Alabama State Port Authority
Addendum to R&P or Specification Booklet

Project Name Terminal Railway Office Addition/Renovation

Project No. 11012 **Task No.** 02 **Addendum No.** 2

| | | | | | | | | | 4146-22 | JDG | 05/31/22 | 4146-S3 | | |

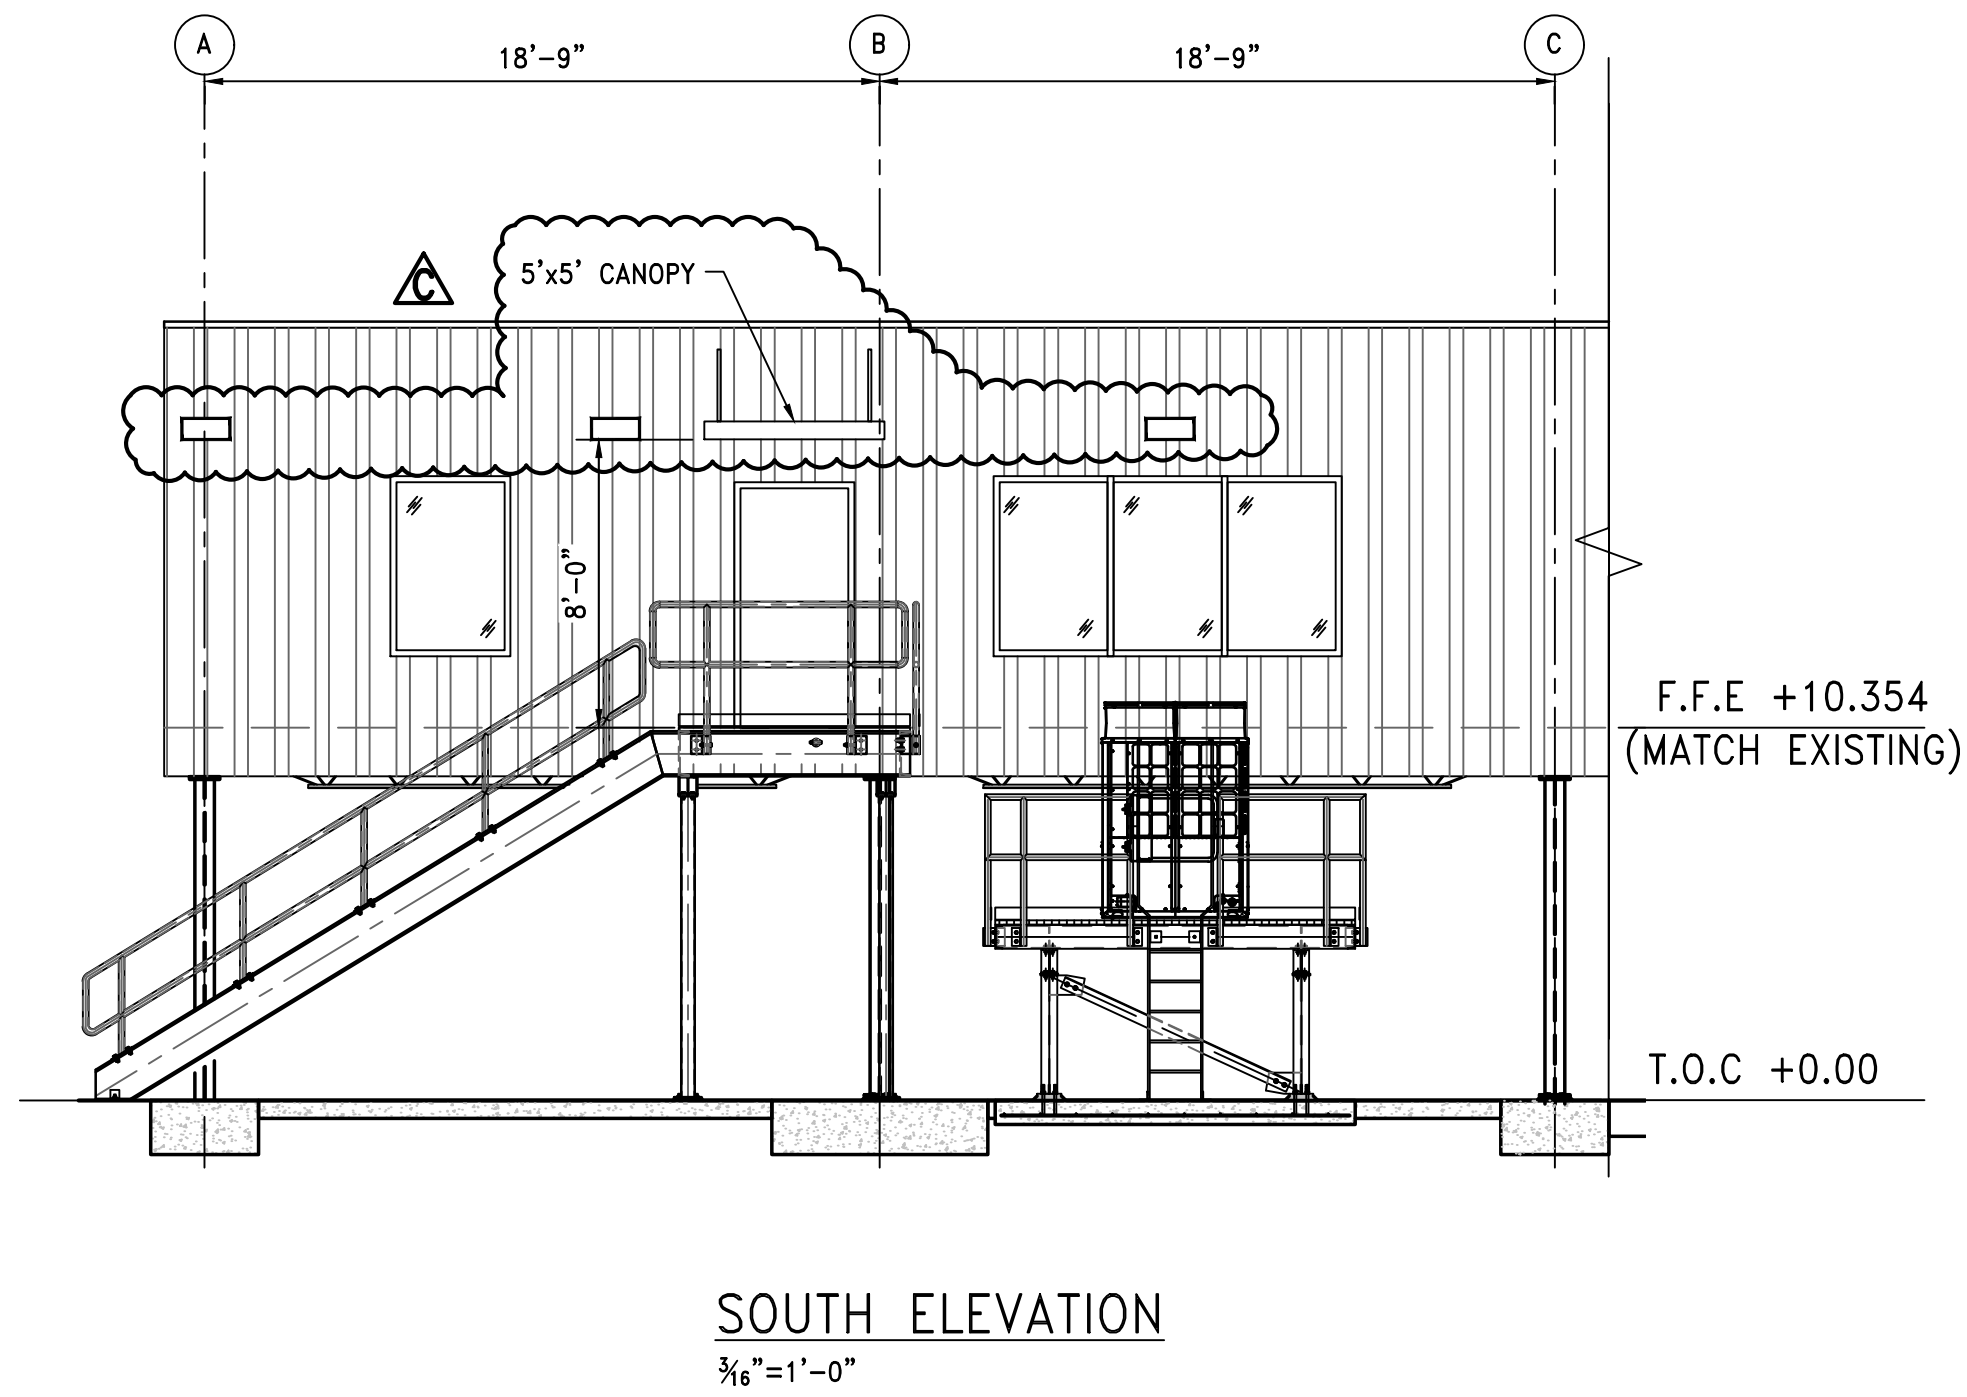
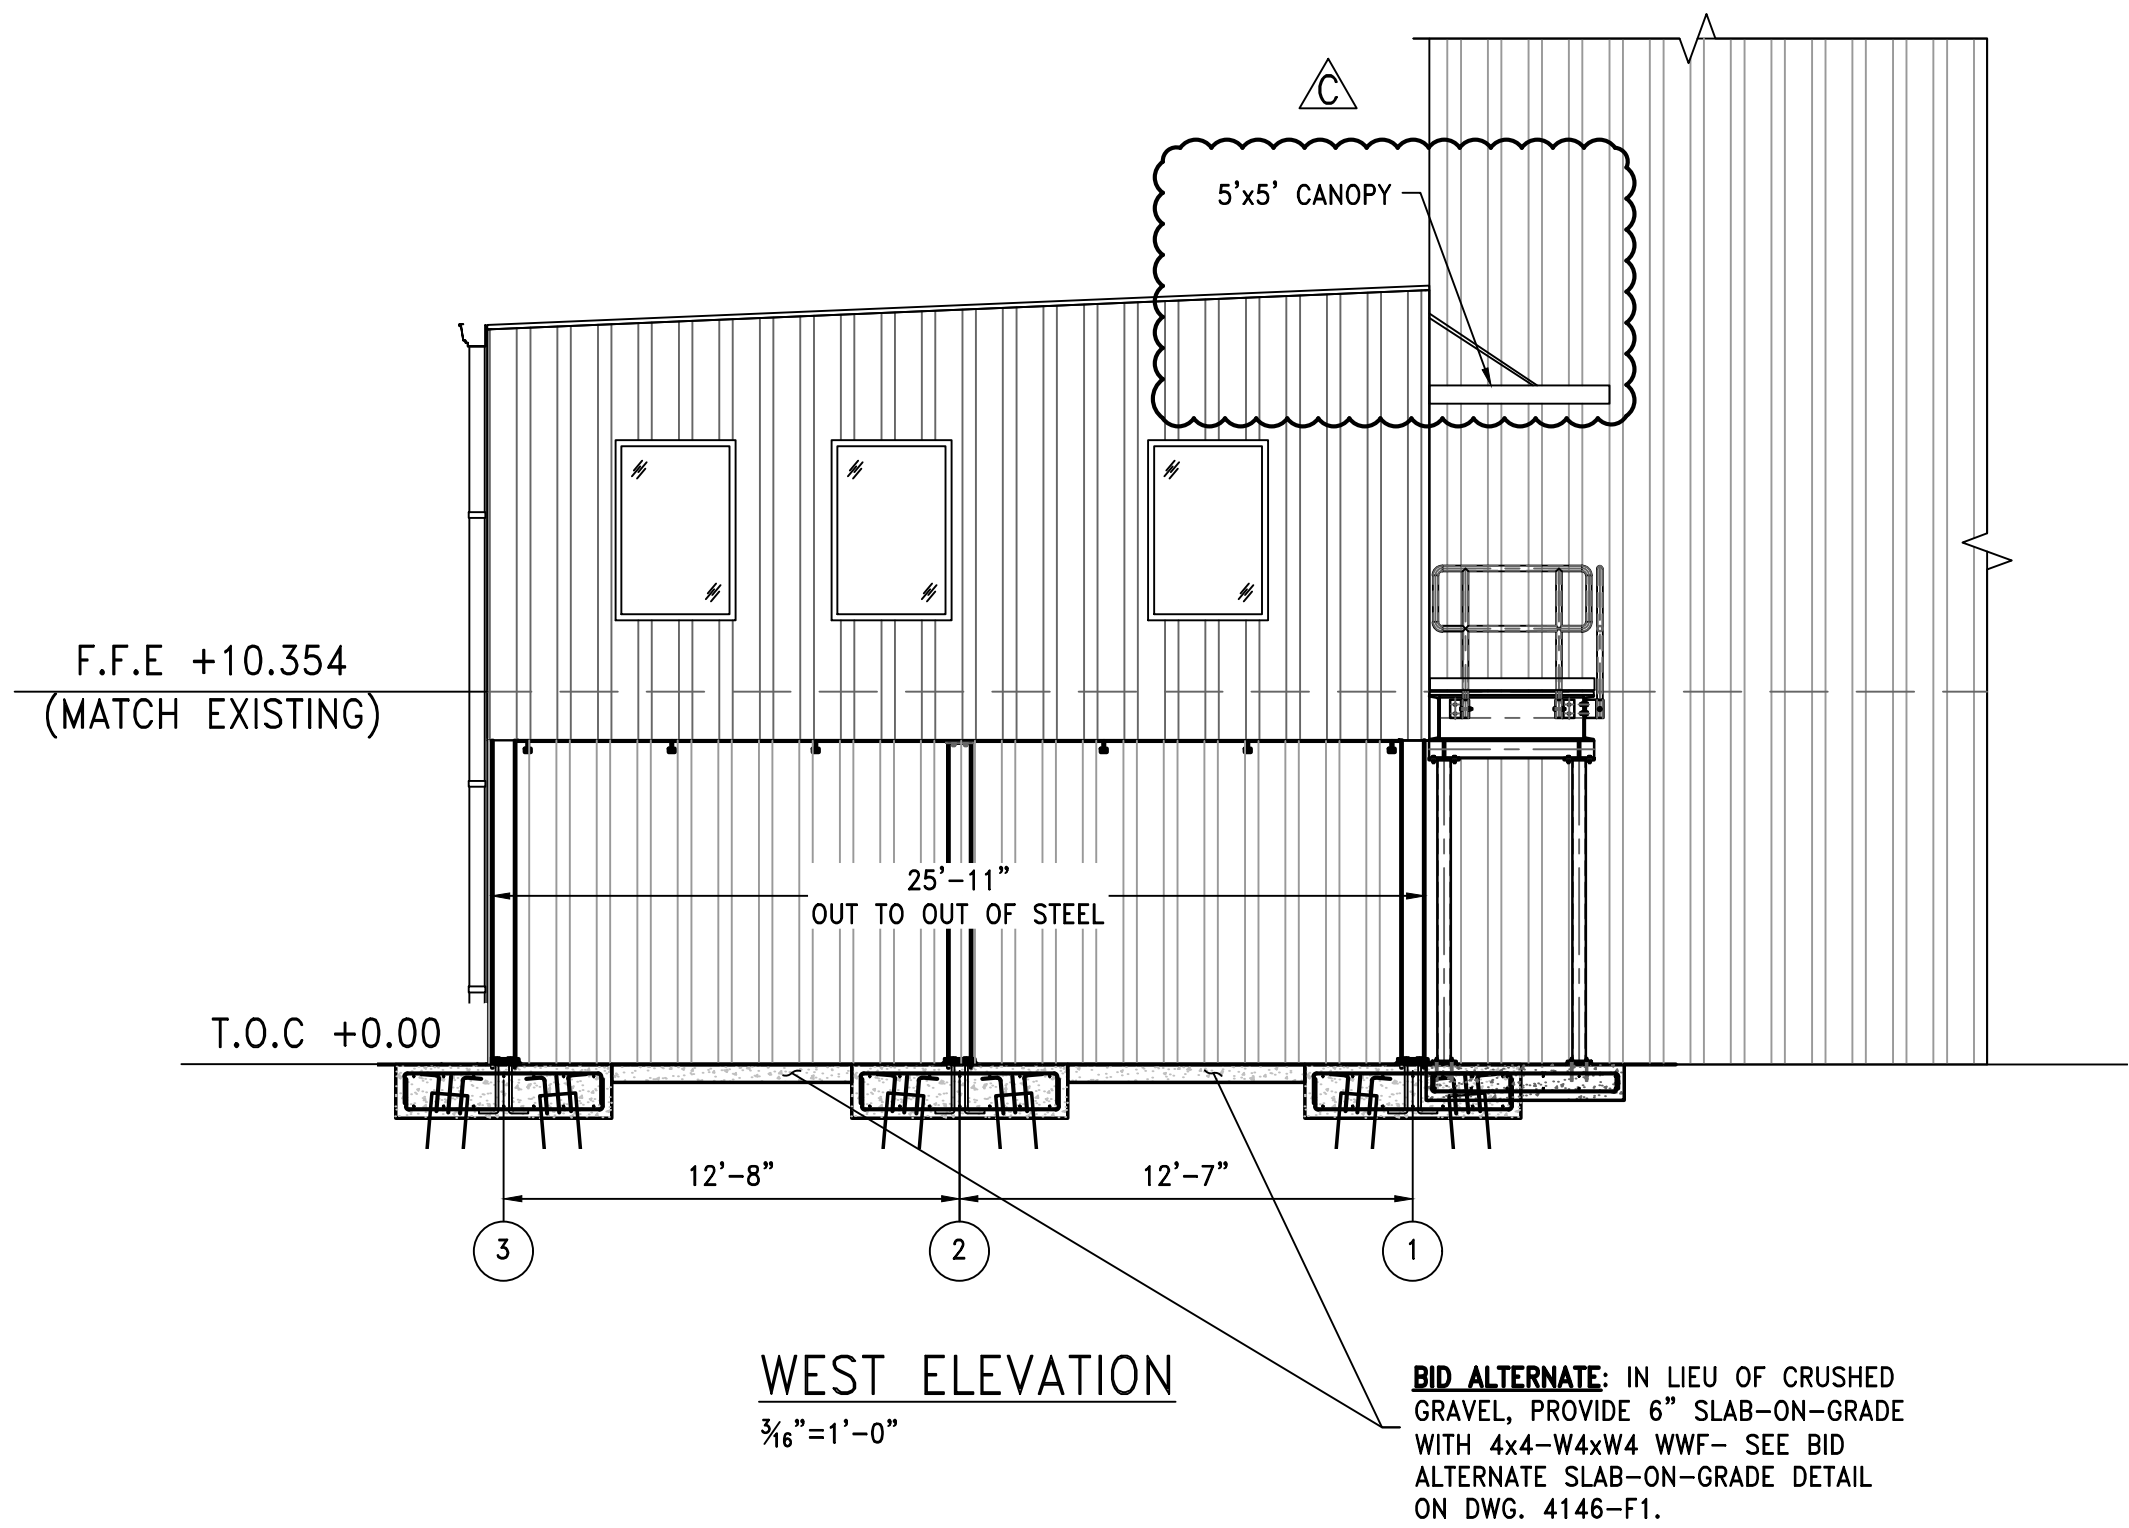
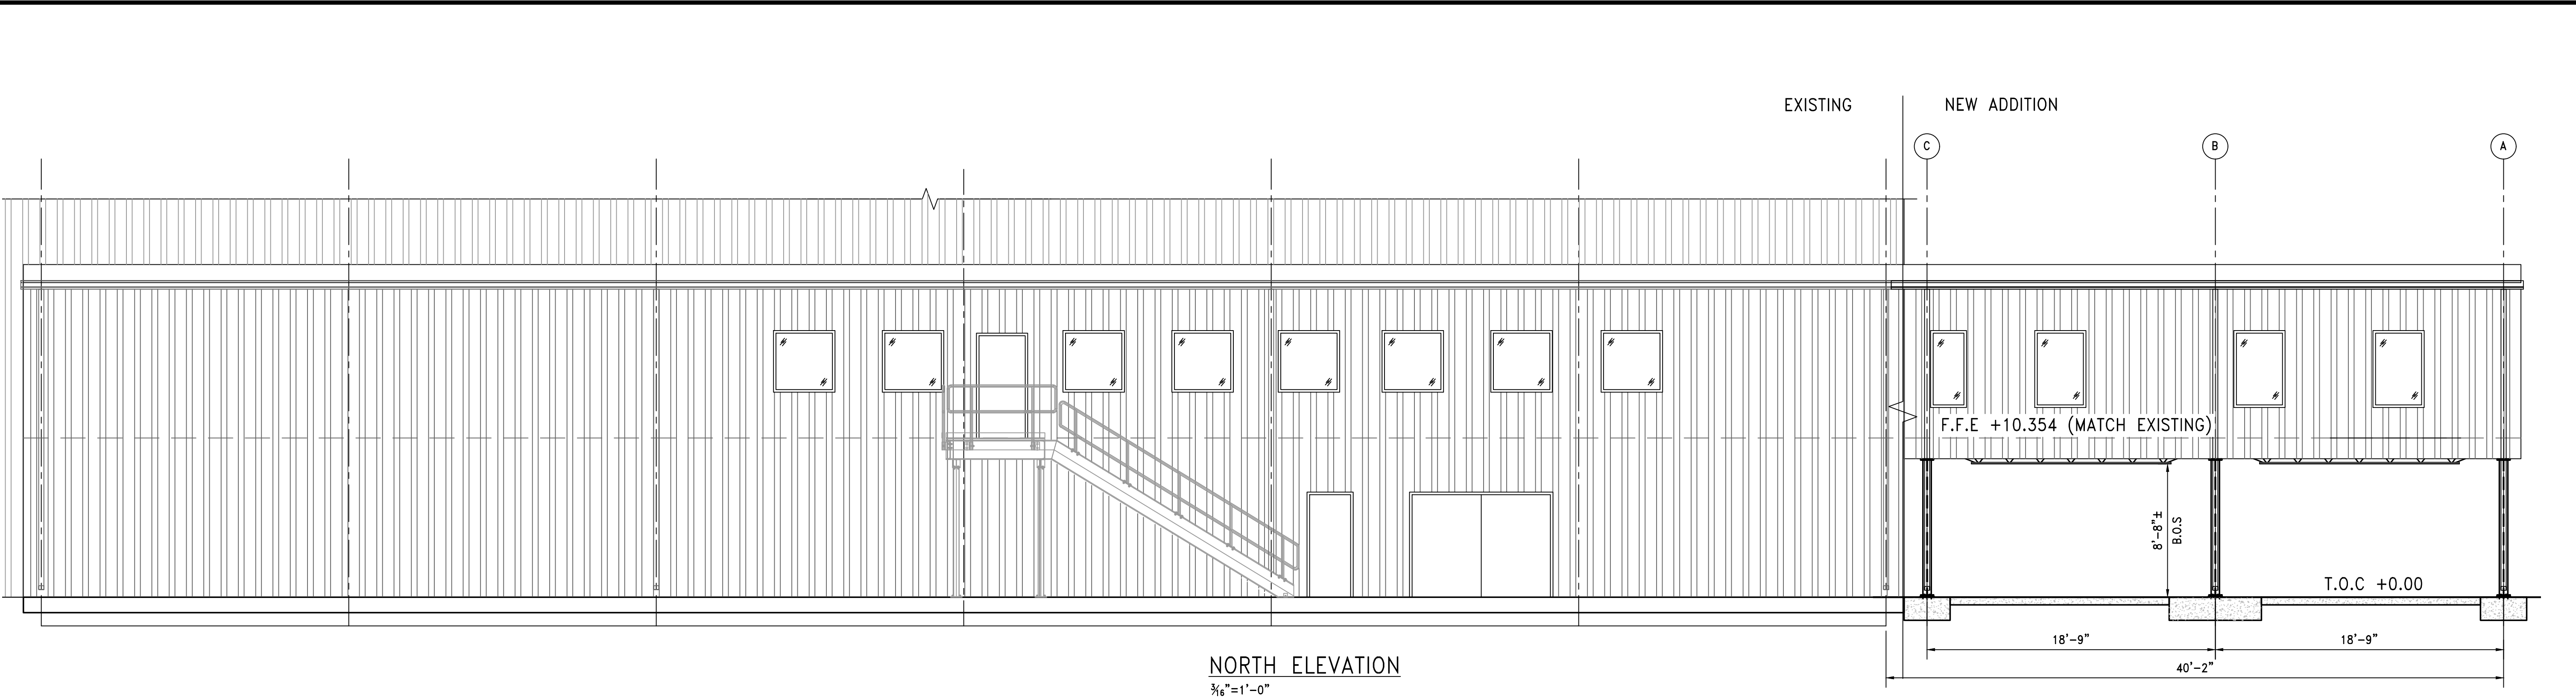
| Item | Description |
|------|---|
| 3. | A 5'x5 exterior canopy has been added above the exterior door on DWG. 4146-S3. DWG. 4146-S3 Rev C is attached and is hereby incorporated into the bid documents by this addendum. |

| C | ADDENDUM 2 ADD EGRESS LIGHTING AND CANOPY | 08/25/22 | JWM | GDEC | 457 St. Michael St., Mobile, AL 36602 13 Thrash Rd., LaGrange, GA 30241 11880 Cranston Dr. Ste 102, Arlington, TN 38002 Alabama (251) 433-1611 Georgia (706) 302-2831 Tennessee (901) 290-5444 | | | | SCALE | DRAWN BY | DATE | SHEET | OF | |
